SANTA CLARA/SANTA CRUZ COUNTIES AIRPORT/COMMUNITY ROUNDTABLE

Fourteenth Regular Meeting of the Roundtable

**October 28, 2020
1:00 – 4:00 PM PDT**

BDEGA usage analysis

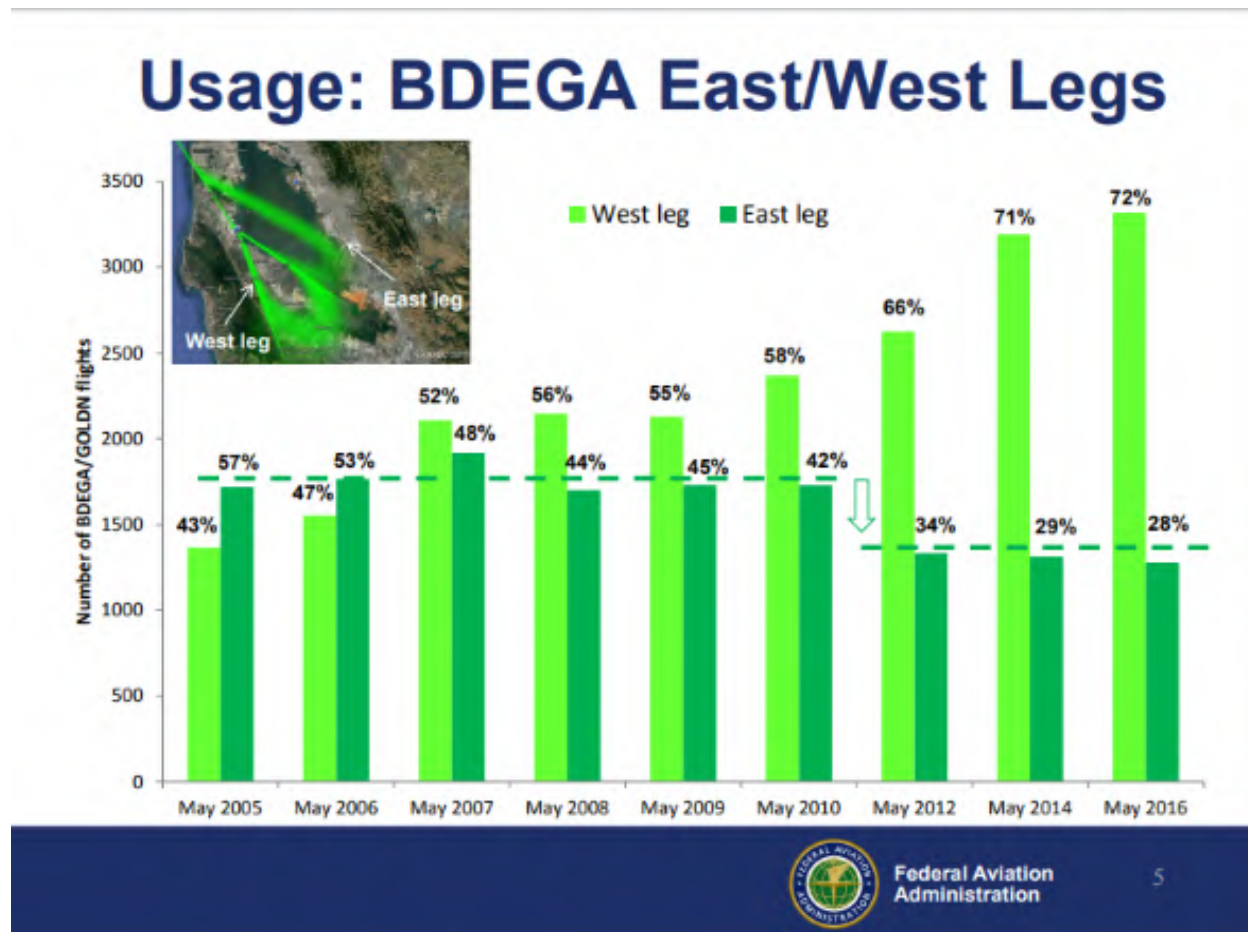
Given the limited improvement observed on the percentage use of BDEGA-east, we would therefore like the FAA to address the following BDEGA questions:

- In particular, please specify whether NIITE/HUSSH departures or OAK departures to FFOIL with transition to YYUNG conflict with BDEGA-east arrivals.
 - Please provide specific reasons why BDEGA-east was used only 40% of the time in May 2020, but 57% of the time in May 2005 when traffic volume was about three times higher.

San Francisco 2018 flight tracks

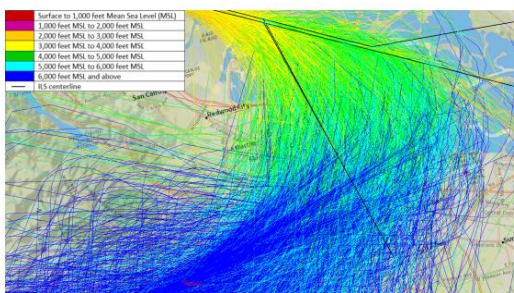
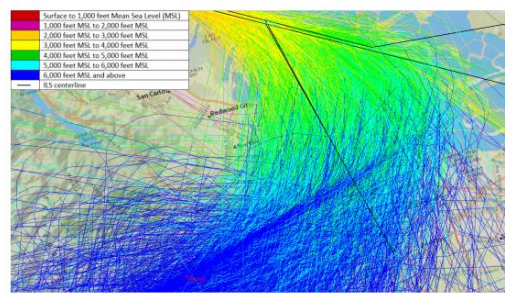
- The FAA personnel involved in the IER should have known that putting in place an RNAV track with a charted heading of 060 that would extend the concentrated track all the way to SIDBY would shift noise because of the much higher level of horizontal concentration of aircraft over the vectoring path between ARGGG and final approach. Replacing two different procedures (TA and non-TA) that had different designs and different noise profiles with one procedure with a new design and a new charted approach with a different heading to SIDBY will create a new noise profile, which is not the combination of the TA and non-TA noise profiles. It is an oversight at best and arguably the use of an invalid method that omits and misrepresents the true impacts to communities. Vectoring PIRAT after ARGGG to final approach using a charted heading of “[on track 060](#)”¹³ is a continuation of the PIRAT STAR procedure past its ending point. Prior to PIRAT, Oceanic arrivals were not charted (TA arrivals may have been but the information was not published) and used a 040 heading after the Woodside VOR to vector the planes to MENLO. **Changing to a charted heading of 060 (e.g., SIDBY) has serious consequences in terms of noise impact and noise shifting** because the planes now fly a **very narrow corridor** (a.k.a., a rail in the sky) with **ground tracks that are not the same as before**.

- Furthermore, the CATEX/ROD document did not specify a charted heading of 060. The CATEX stated instead that aircraft would be vectored by ATC after ARGGG. The **FAA implemented something different than what was assessed in the environmental review process and signed in the Record Of Decision**. The PIRAT CATEX/ROD stated that “At ARGGG, ATC will vector

FIGURE 1. Big Sur RNAV STAR Notional Design: Descent Gradient Criteria

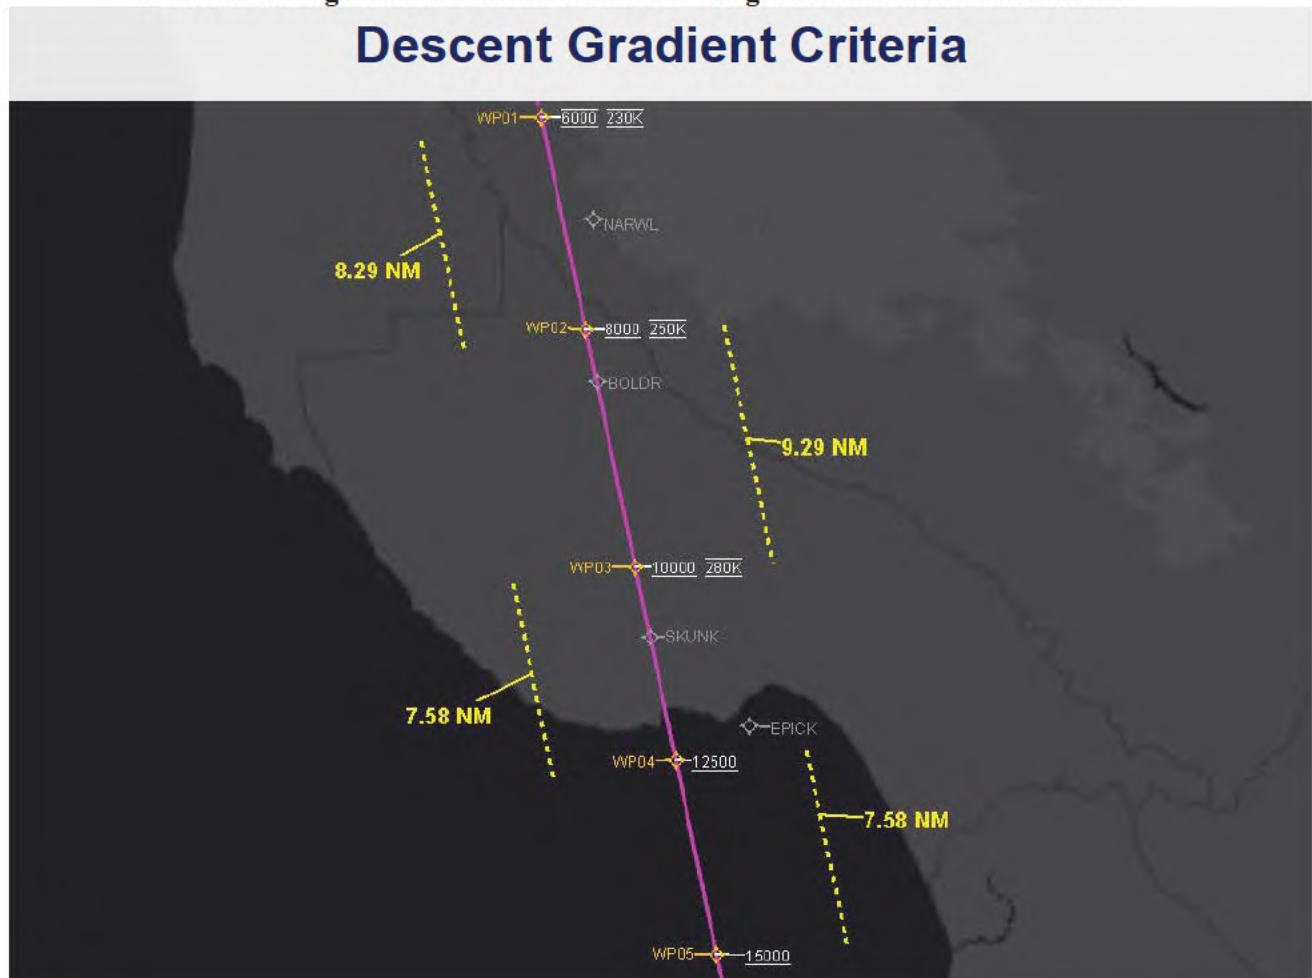
2. JH presented a notional RNAV STAR design demonstrating the location of speed and altitude restrictions overlying the BSR lateral track that would be required to comply with design criteria. Also presented were illustrations comparing the Select Committee recommendations and the resultant design challenges for FWG consideration (See **Figure 1**).

FIGURE 2. Big Sur RNAV STAR Notional Design

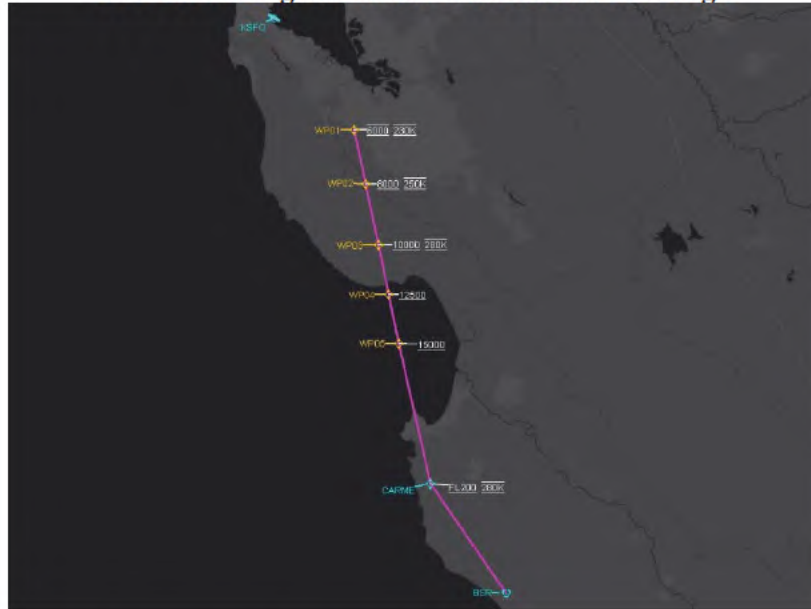
3. JH proposed a methodology as to how the FWG should proceed for analyzing and discussing the notional design (See **Figure 2**.), suggesting starting from WP01 and working southward to the BSR VOR.

FIGURE 4. WP02 Segment

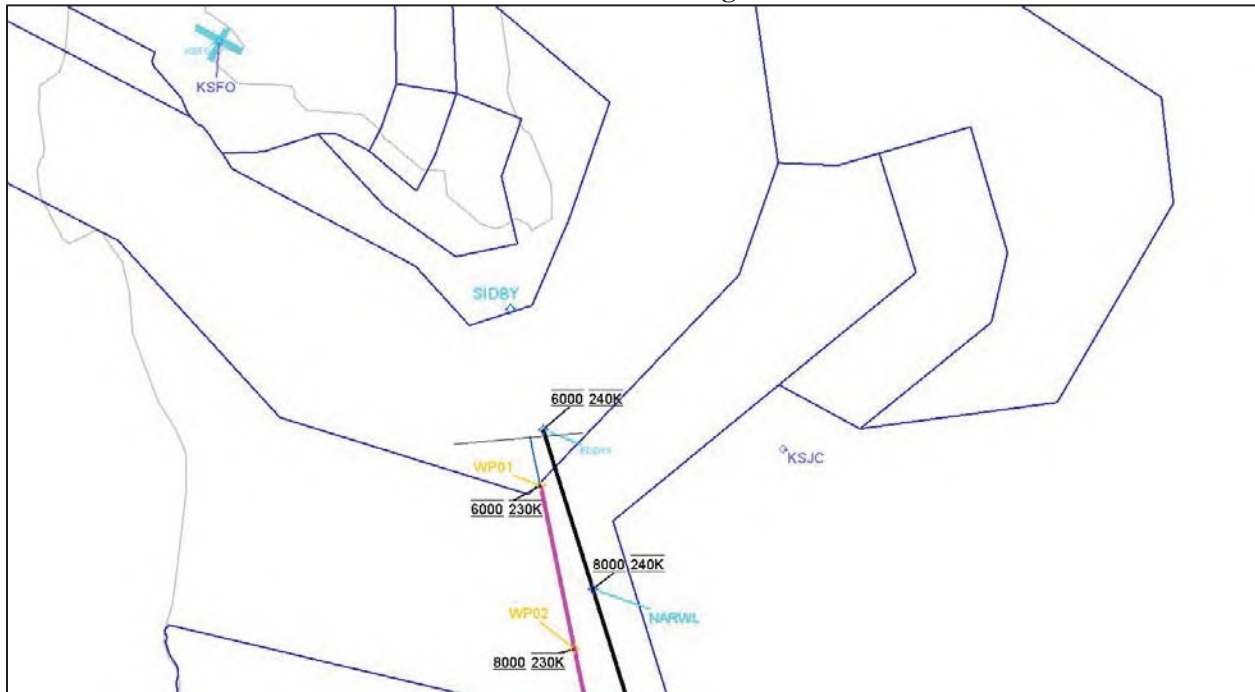
- b. JH queried the FWG as to feasibility of the WP02 segment (See **Figure 4**.)

- (1) The FWG experimented with moving WP02 2NM to the north, At Or Above (AOA) 8,000'. The Targets Operator (TO) adjusted the notional design and the relocated WP02, still meeting design criteria.

FIGURE 5. WP03 Segment

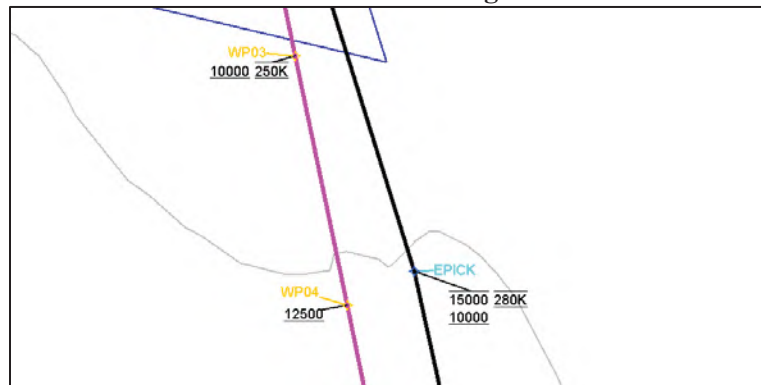
- c. JH queried the FWG as to feasibility of the WP03 segment (See **Figure 5**.)
 - (1) The TO also moved WP03 to a location that criteria allowed 10,000' @ 250KTS. This is the criteria changeover point from 318'/NM to 330'/NM (descent gradient criteria)
- d. The TO created an additional waypoint (WP215) on the procedure at the 11,000' mark, to allow for TARGETS rounding errors
 - (a) (Note: WP215 was later removed as it was deemed unnecessary for criteria)

Figure 7. TARGETS Simulation Results near WP04

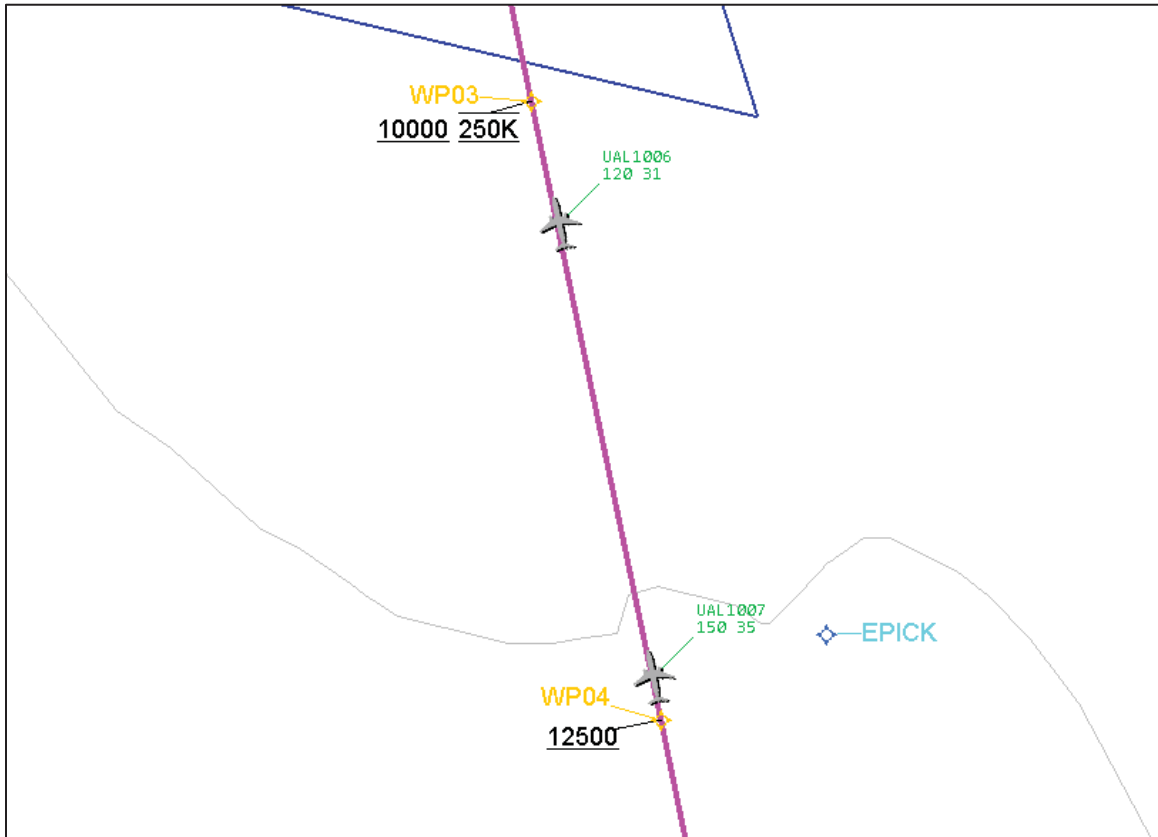
- e. JH queried the FWG as to feasibility of the WP04 segment (See **Figure 6.**)
 - (1) The FWG experimented with where 12,500' @ 280KTS would be located (WP04) on the procedure and if it would resemble the Select Committee recommendation (over Monterey Bay)
 - (a) WP04's new location is approximately 2.2NM from the shoreline
 - (2) The TO performed a TARGETS flight simulation to demonstrate approximate aircraft altitudes near the 12,500' restriction at WP04 (based on average B737 performance with no winds aloft).

- b. TO performed a TARGETS Flight Evaluation to demonstrate average aircraft performance when approach the AoA12,500' restriction at WP04. (See **Figure 7.**)

FIGURE 8. WP04 - ANJEE Segment

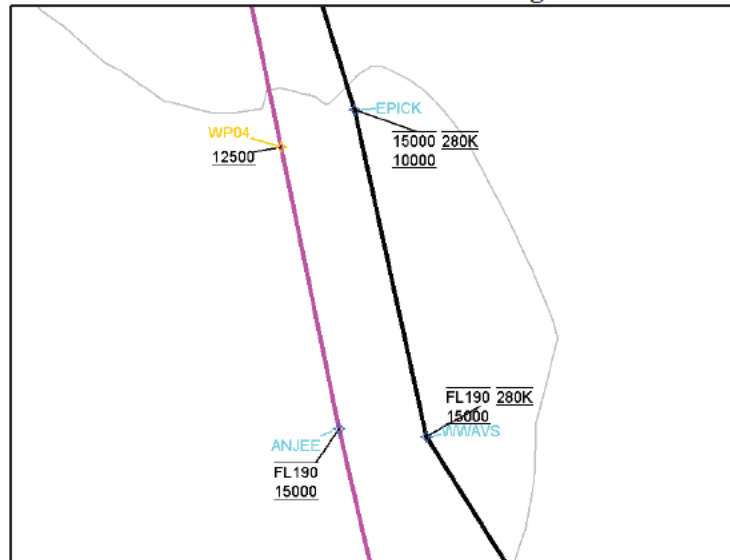
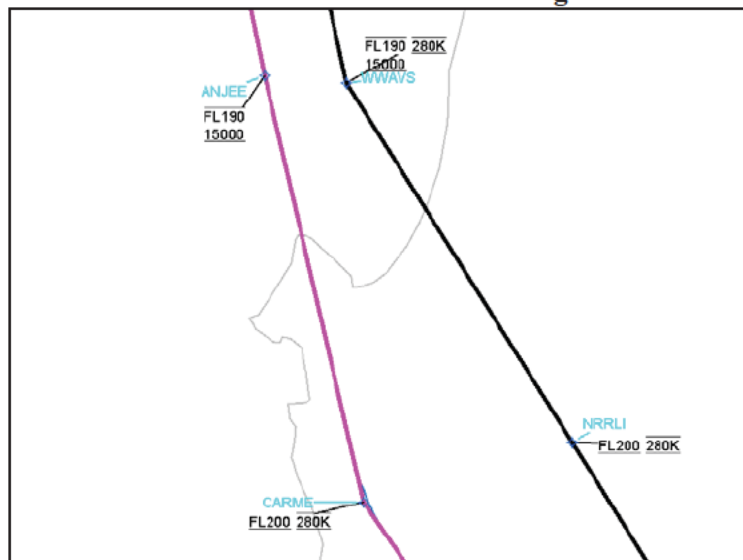
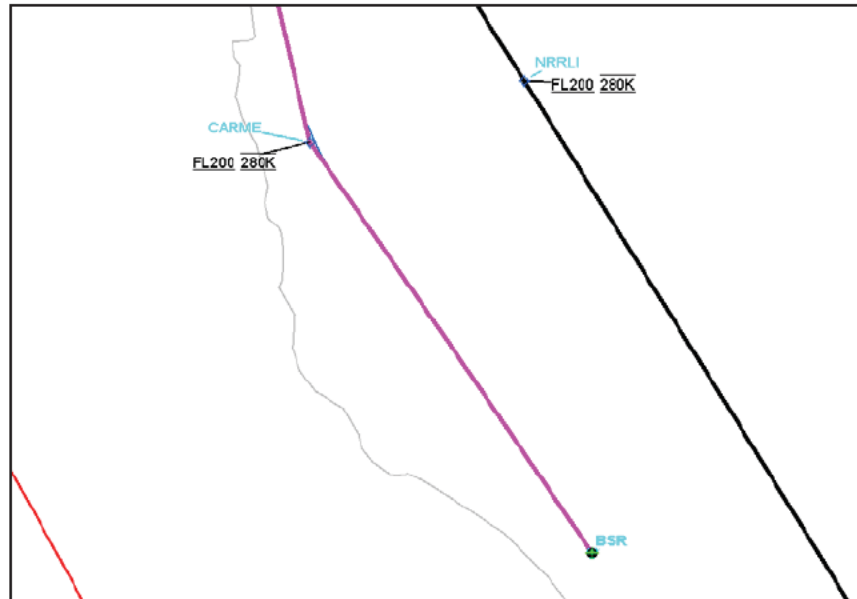
- c. JH queried the FWG as to feasibility of the WP05 segment and remaining points beyond (See **Figures 8-10.**)
- (1) WP05 required relocation (south) to allow the procedure to conform to descent gradient criteria.
